UNITED STATES
NUCLEAR REGULATORY COMMISSION

LICENSEE: Energy Northwest

FACILITY: WNP-2

SUBJECT: SUMMARY OF MEETING WITH ENERGY NORTHWEST REGARDING THE
PROPOSED SECONDARY CONTAINMENT/STANDBY GAS TREATMENT
SUBMITTAL

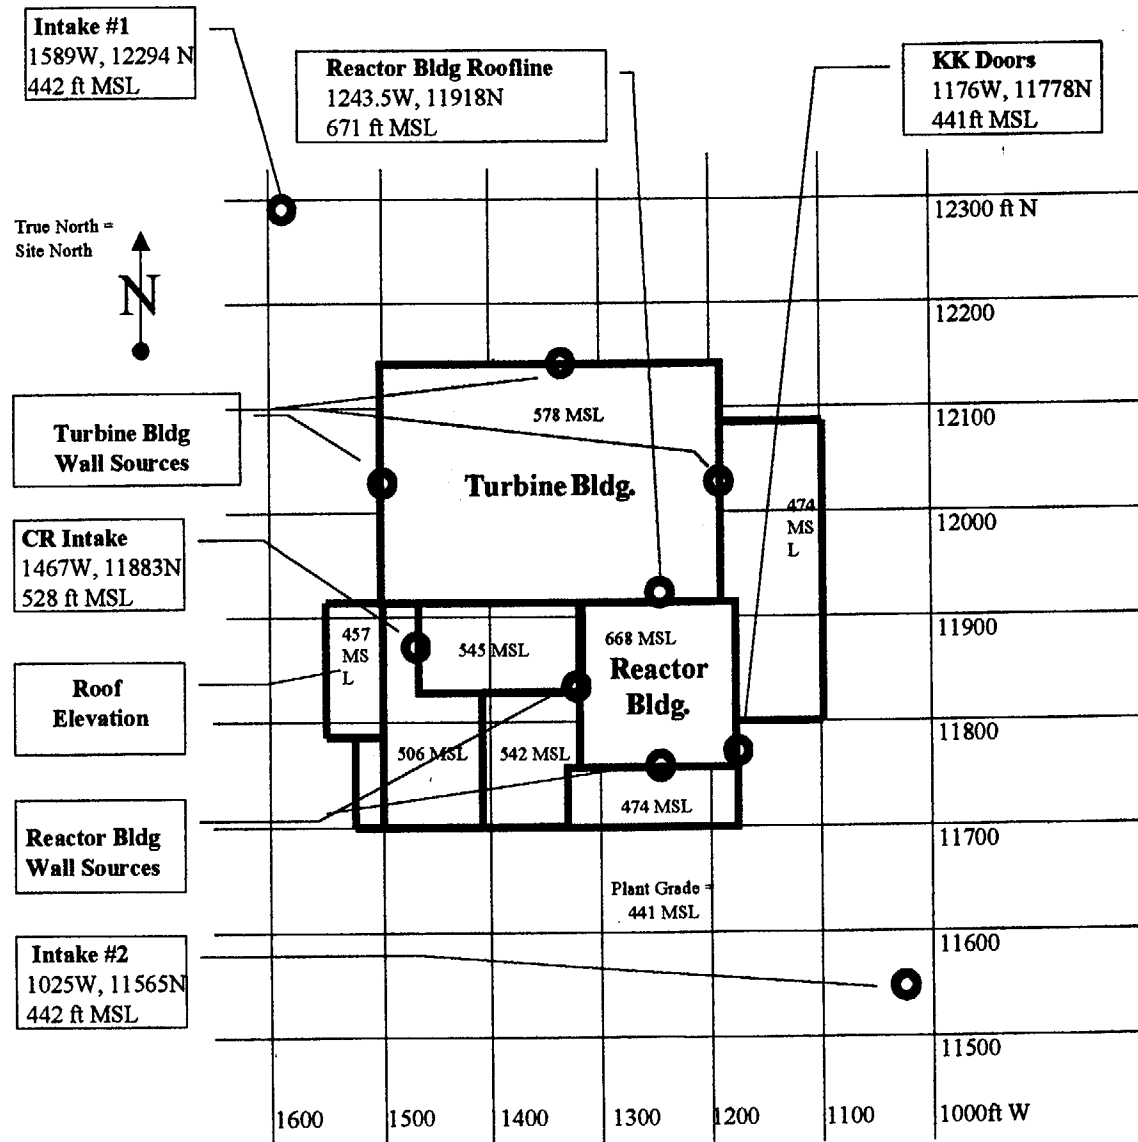
control room intakes were useful to the staff in understanding the assumptions that were made. The staff expressed a concern with the vent option used in the ARCON 96 Code that was used to calculate some of the control room atmospheric dispersion factors. It was suggested that an acceptable solution would be to recalculate the vent run cases as a ground release option using ARCON 96.

control room intakes were useful to the staff in understanding the assumptions that were made. The staff expressed a concern with the vent option used in the ARCON 96 Code that was used to calculate some of the control room atmospheric dispersion factors. It was suggested that an acceptable solution would be to recalculate the vent run cases as a ground release option using ARCON 96.
